STAFF REPORT
COMMUNITY DEVELOPMENT DEPARTMENT

SUBJECT: Apex Cadence No. 1 – MFP
MFP-2026-0006

LOCATION: 6575 S. Locust Grove Rd., in the NE 1/4
of Section 6, T.2N., R.1E. (Parcel
#S1406110355)

PLAT OF APEX CADENCE SUBDIVISION No. 1

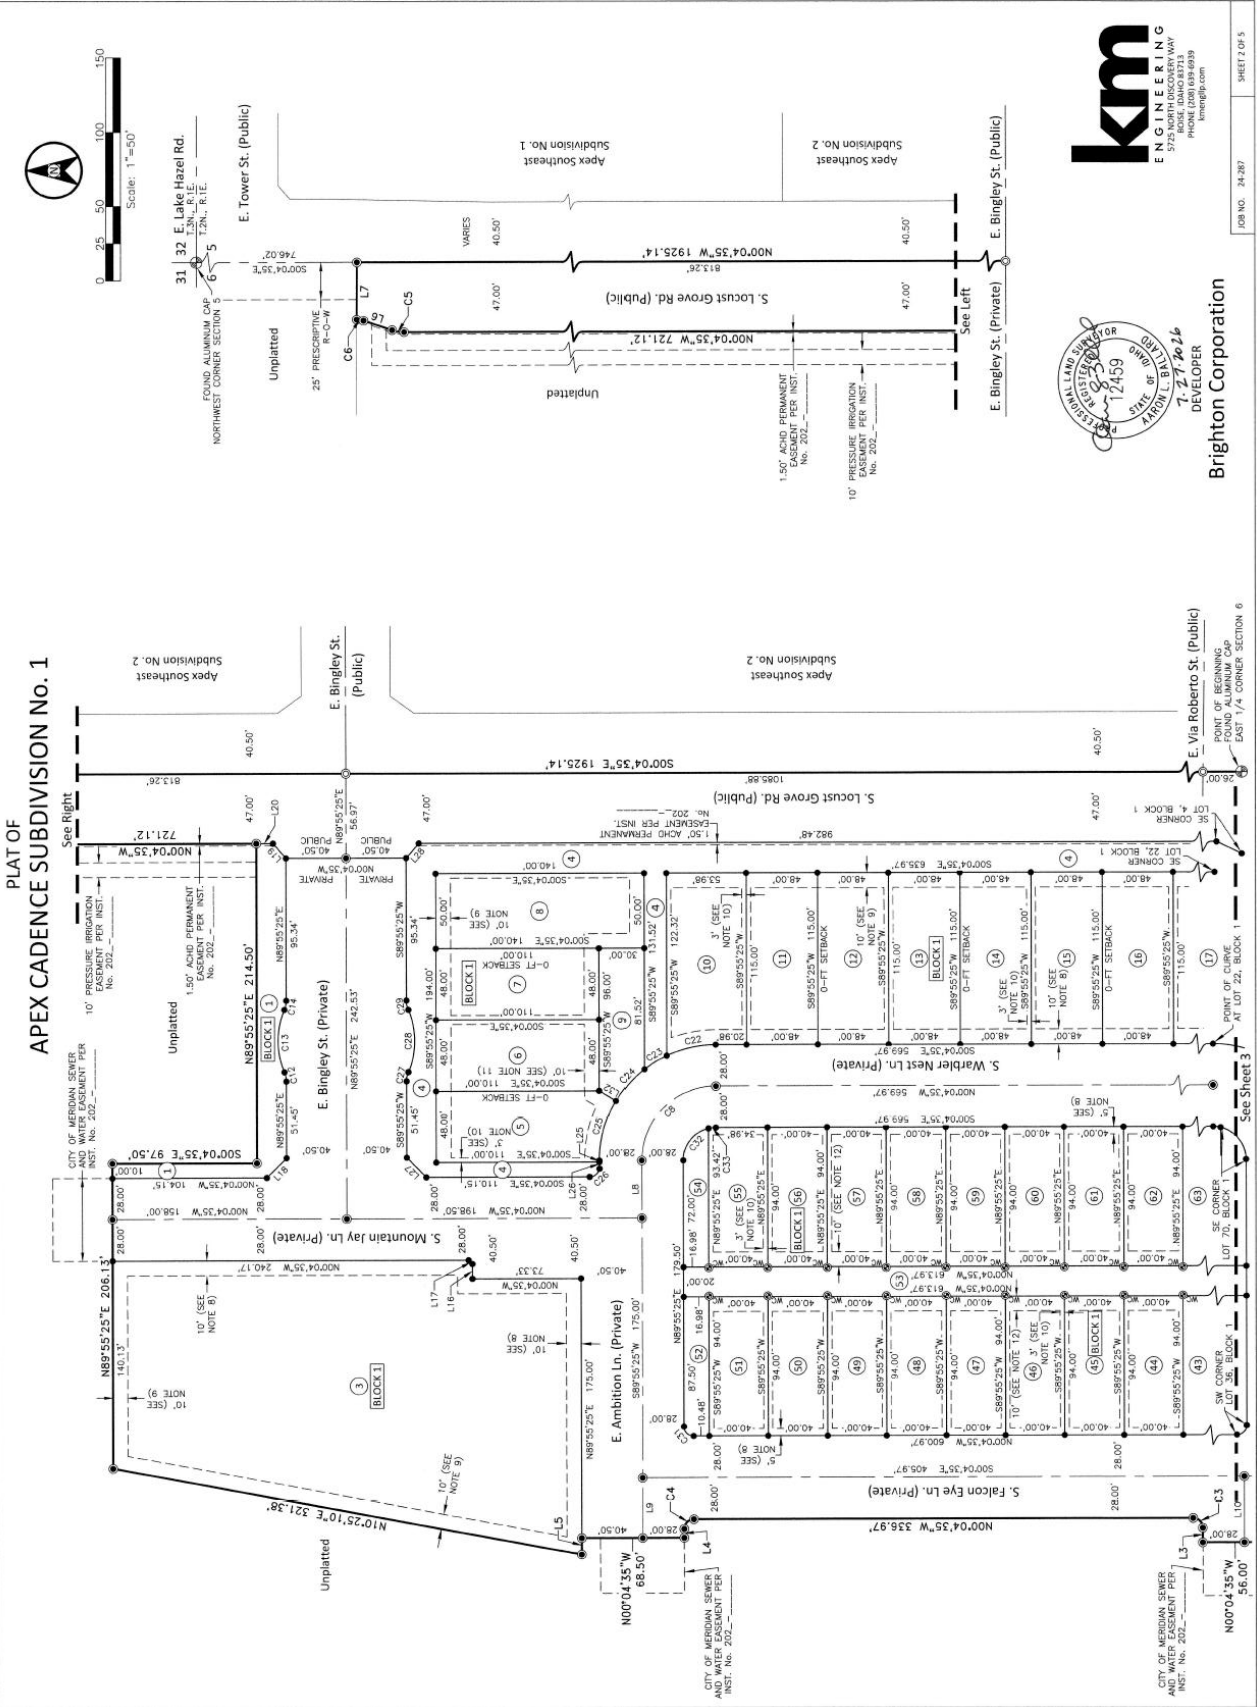
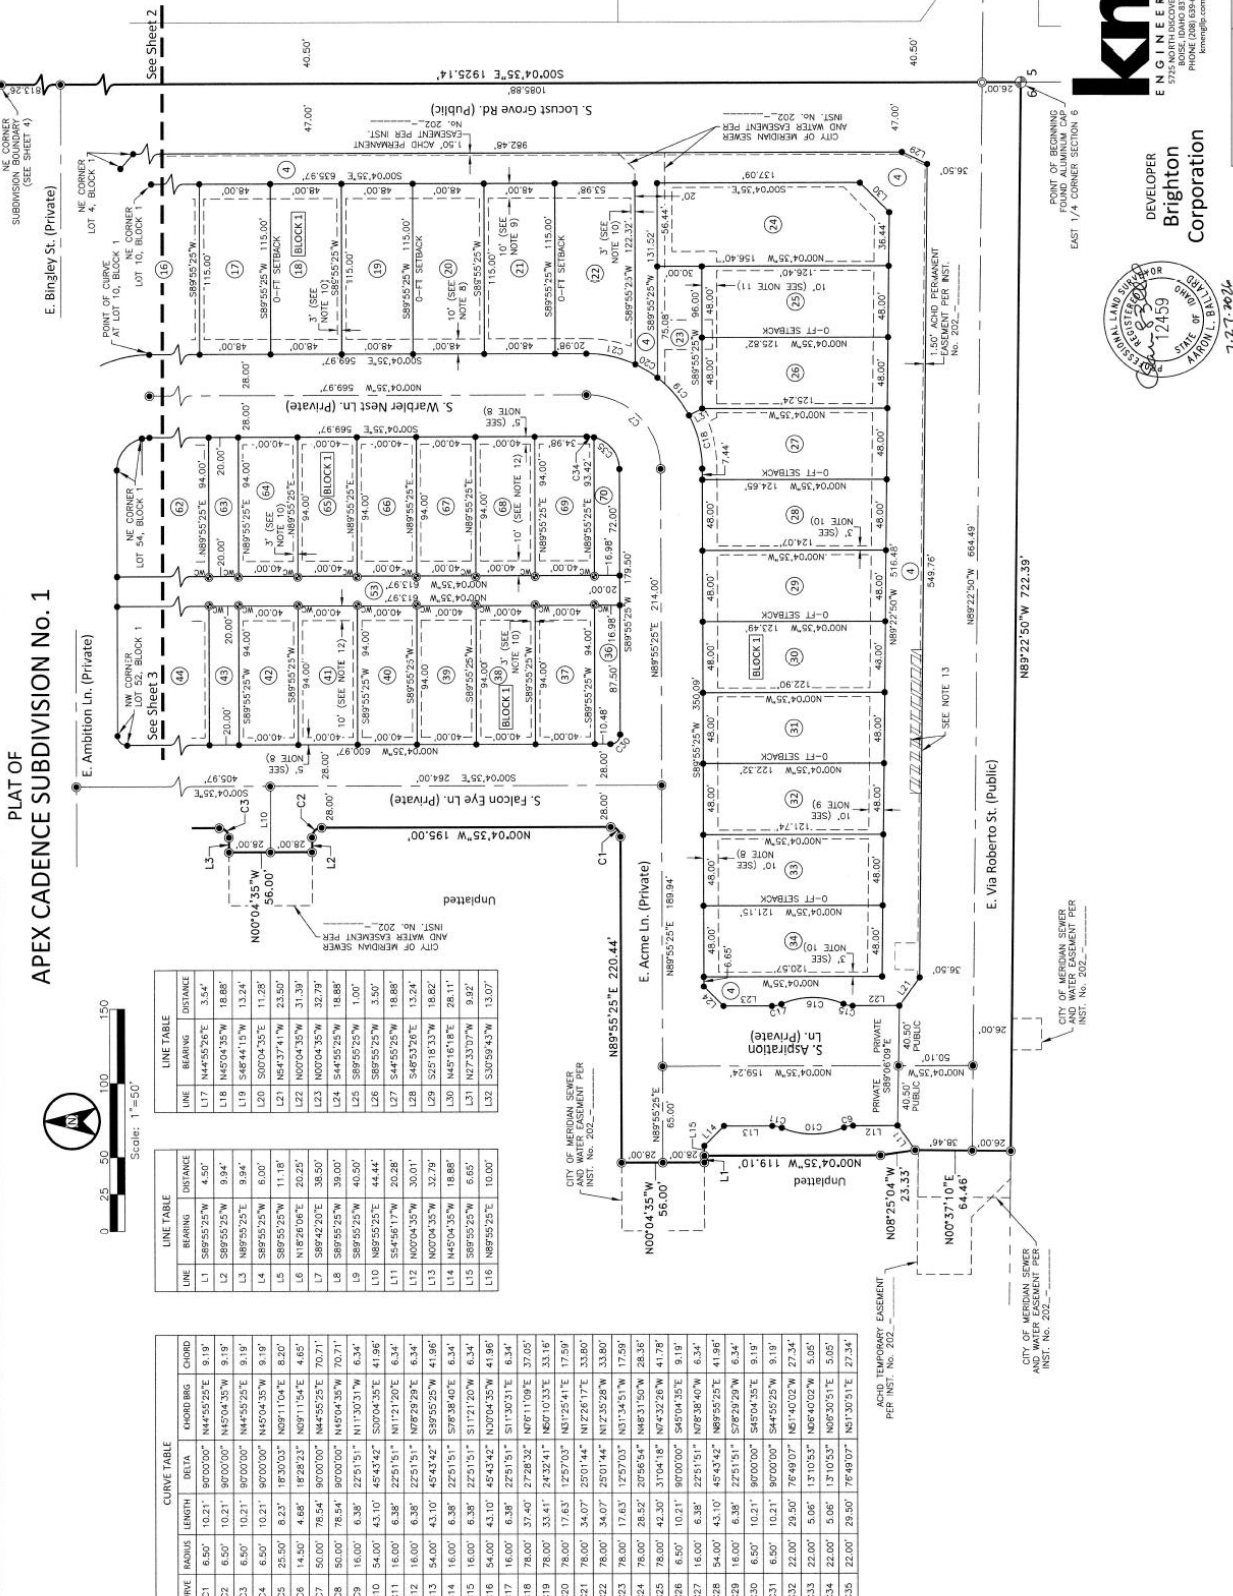
3. Prior to submittal for the City Engineer's signature, have the Certificate of Owners and the accompanying acknowledgement signed and notarized.
4. The final plat prepared by KM Engineering, dated: 07/27/2026, included in Section V.C shall be revised as follows:

- a. Note #6: Include that the private street shall provide perpetual ingress-egress to all lots in the subdivision; and include the recorded instrument number of the City water and sewer easement.

- b. Note #7: Lots 9 and 23, Block 1 shall be maintained by the homeowner's association, not the adjacent lot owners that take access via the common driveways – revise note accordingly.

- c. Note #11: "As shown hereon, the lots lines common to Lots 9 and 23, Block 1 . . ."
 - d. Note #12: "As shown hereon, the lots lines common to Lot 53, Block 1 . . ."

- e. Note #14: Include the recorded instrument number of the ACHD temporary license agreement.
 - f. Note #15: "Direct lot access to E. Via Roberto St. and S. Locust Grove Rd. is prohibited ~~unless otherwise approved by Ada County Highway District and the City of Meridian.~~"

- g. Note #16: Ensure the recorded instrument number for the CC&R's is correct (the year of the recorded instrument is prior to the approval date of the plat).

- h. Include the recorded instrument number of the City of Meridian sewer and water easement graphically depicted on Sheets 2 and 3.
 - i. Include the recorded instrument number of the ACHD permanent easement graphically depicted on Sheet 2 and 3.

- j. Include the recorded instrument number of the ACHD temporary easement graphically depicted on Sheet 3
 - k. Include the recorded instrument number of the 10' pressure irrigation easement on Sheet 2.

- l. If the multi-use pathways/sidewalks along E. Via Roberto St. and S. Locust Grove Rd. aren't located entirely within the right-of-way, public use easement(s) shall be depicted on the plat.

- m. Depict the easement for the Watkins Drain, if applicable.
 - n. Extend Lots 9 and 23, Block 1 along the frontage of Lots 8 and 24, Block 1.

LANDSCAPE CONSTRUCTION SET
MERIDIAN, IDAHO
APEX CADENCE SUBDIVISION NO. 1
FENCE PLAN

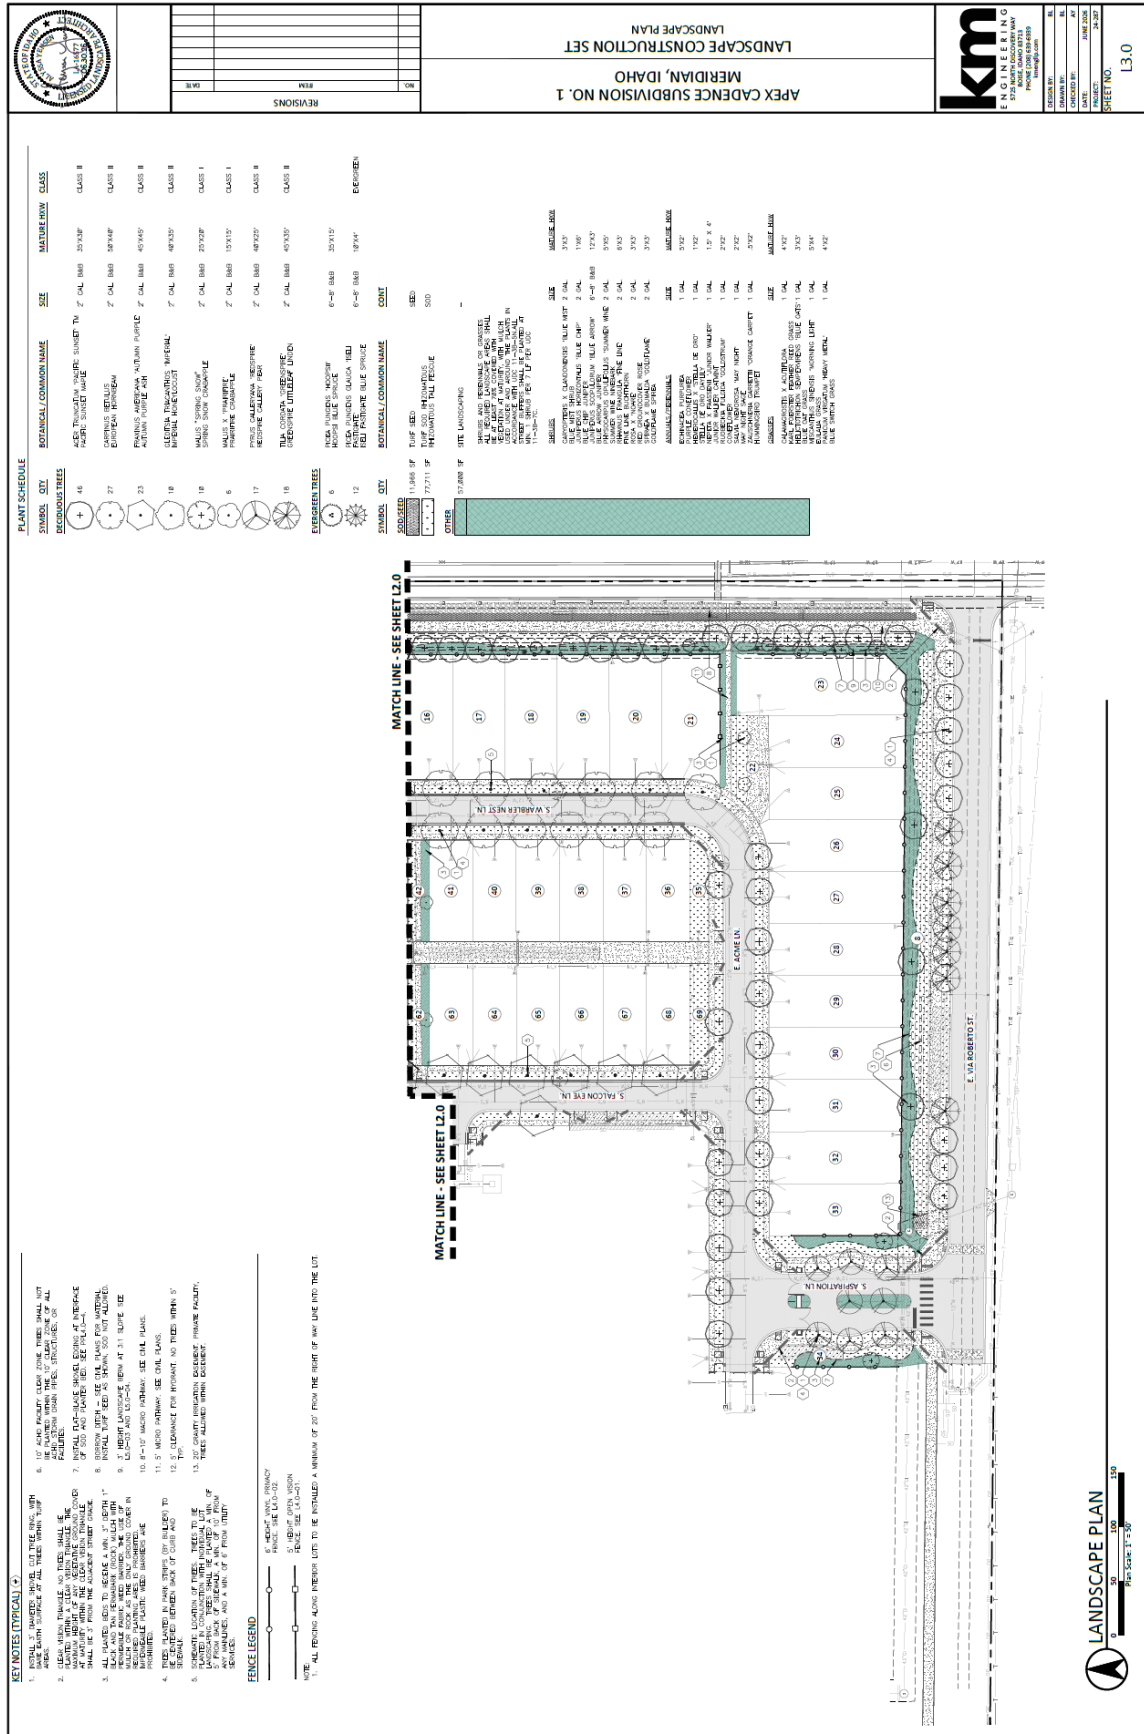
5. The landscape plan prepared by KM Engineering, dated 06/30/2026, included in Section V.D, shall be revised as follows:
 - a. Depict enhanced landscaping within the street buffers along S. Locust Grove Rd., an arterial street, and E. Via Roberto St., a collector street, in accord with the standards listed in UDC 11-3B-7C. and 11-3G-3B.3. Include a note stating what the enhanced landscaping consists of.

- b. Include tree mitigation calculations on the landscape plan in accord with the standards in UDC 11-3B-10C.5, as applicable.
 - c. Correct Detail #4 on Sheet L5.0 to reflect a 10' wide detached sidewalk/pathway rather than a 5' wide detached sidewalk/pathway along Locust Grove Rd.

- d. The 6' height vinyl privacy fence depicted in the Fence Legend doesn't match Detail 2 on Sheet L4.0, which is a 6' height stained cedar fence – revise accordingly.

- e. Depict fencing abutting pathways and common open space lots to distinguish common from private areas as set forth in UDC 11-3A-7A.7.
 - f. Extend Lots 9 and 23, Block 1 along the frontage of Lots 8 and 24, Block 1 and extend landscape strips along common driveways.

COMMON DRIVE EXHIBITS
LOTS 22-26, BLOCK 1

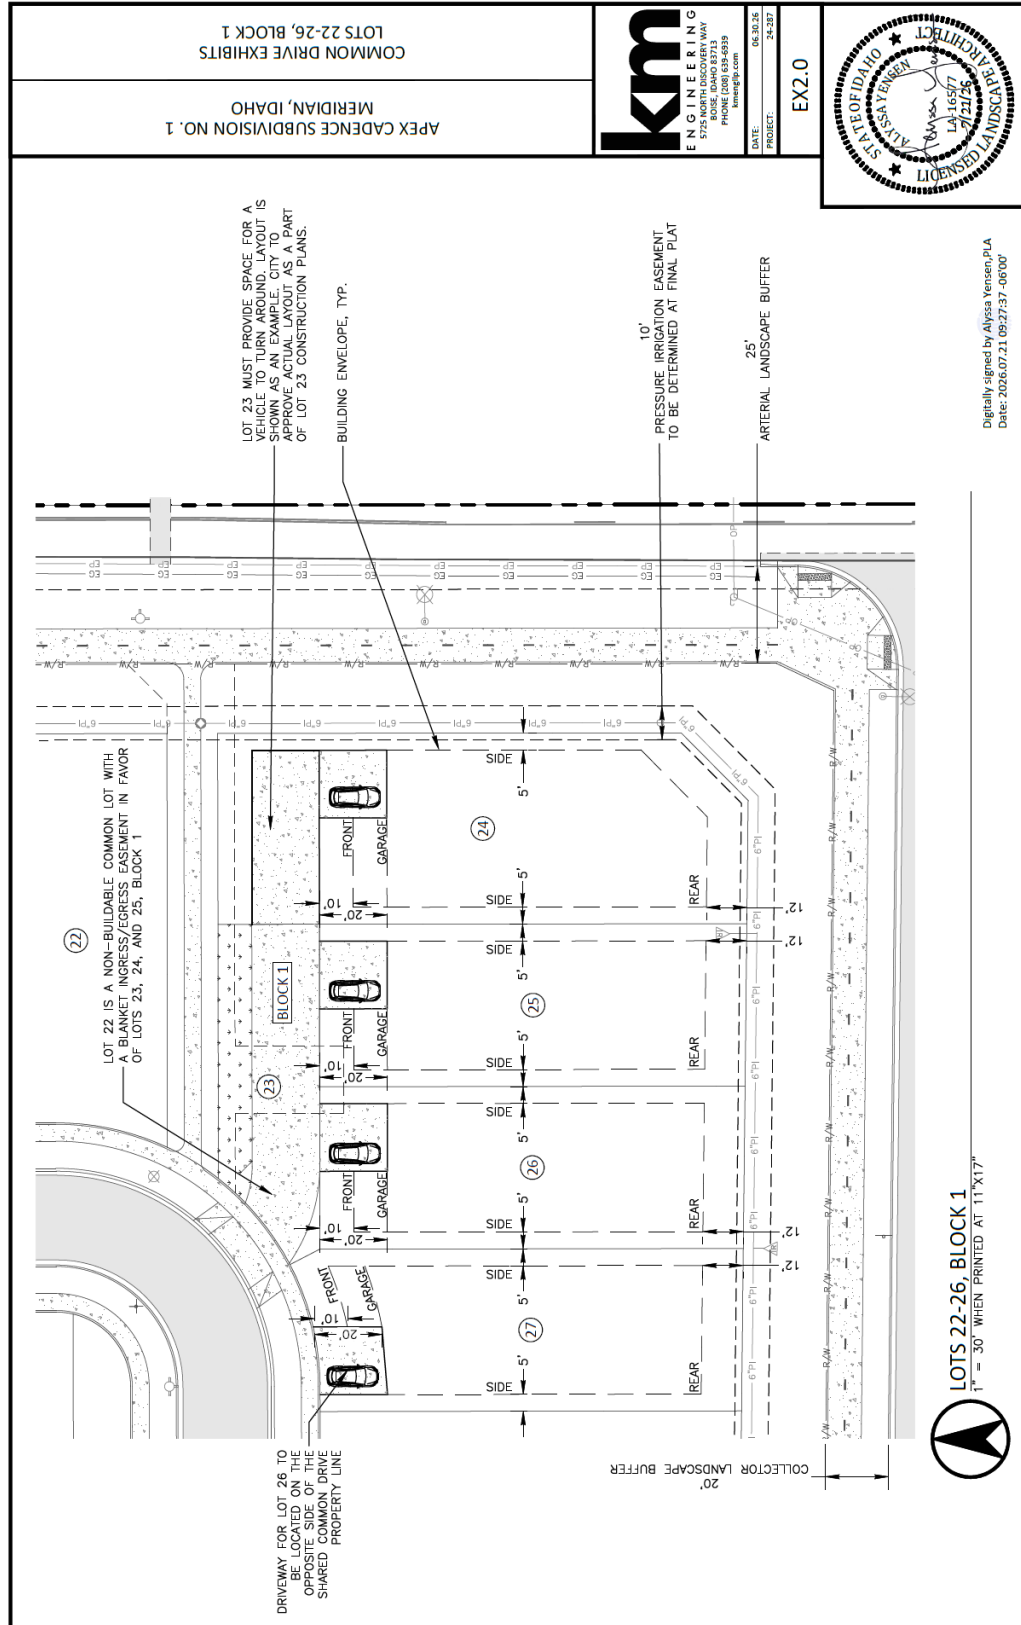
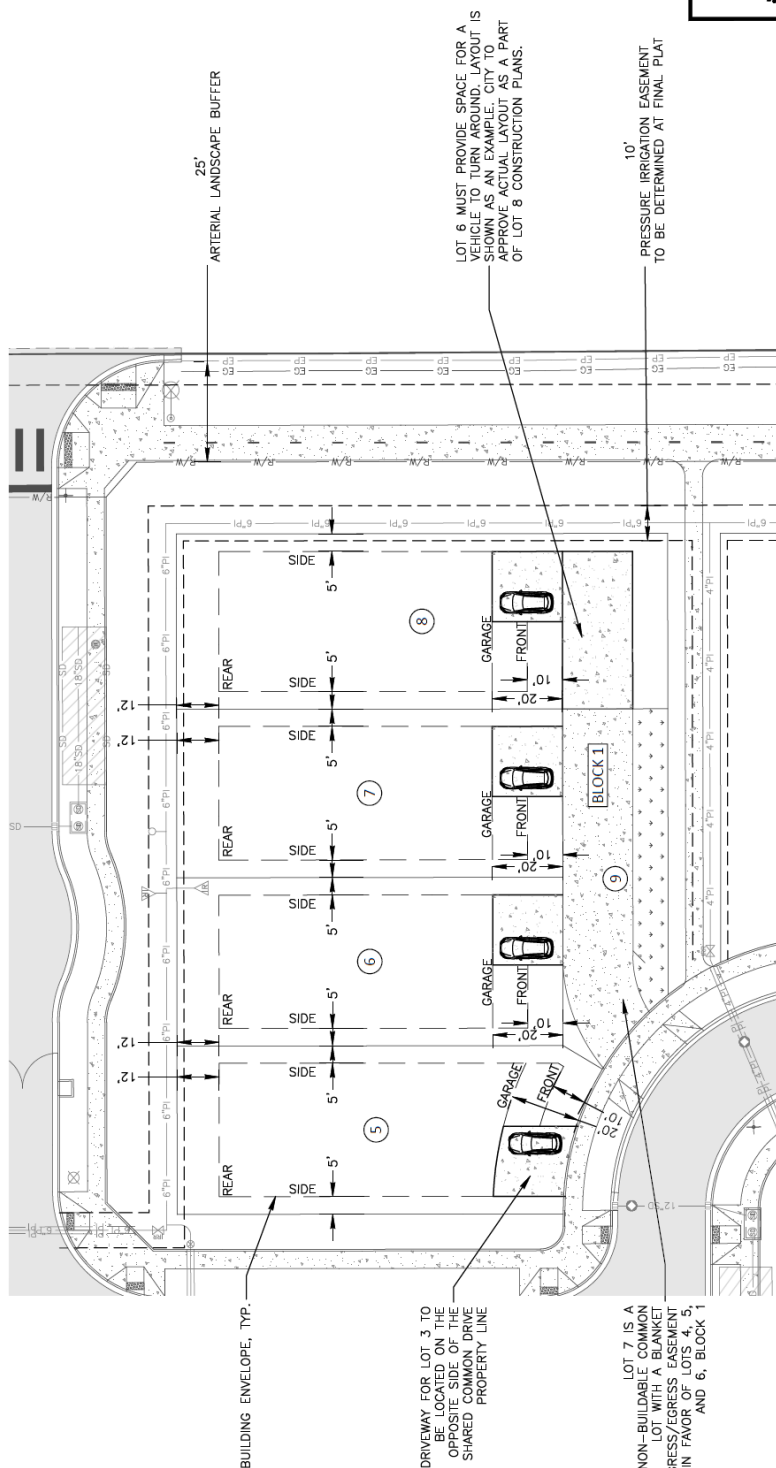
20. The common driveways on Lots 9 and 23, Block 1 shall be constructed in accord with the standards listed in UDC 11-6C-3D. The common drive exhibits included above in Section VII.E, shall be revised as follows:

- a. Correct the lot numbers on the notes for the common driveway lots.
 - b. Specify in the note that the common driveways must provide space for vehicles on the end lots to back-up/turn around.

- c. Depict fencing to delineate common from private areas in accord with UDC 11-3A.7A.7.
21. The subject property shall be subdivided prior to submittal of any building permit applications for the development, except for permits associated with the community amenities, including, but not limited to, the clubhouse and swimming pool.
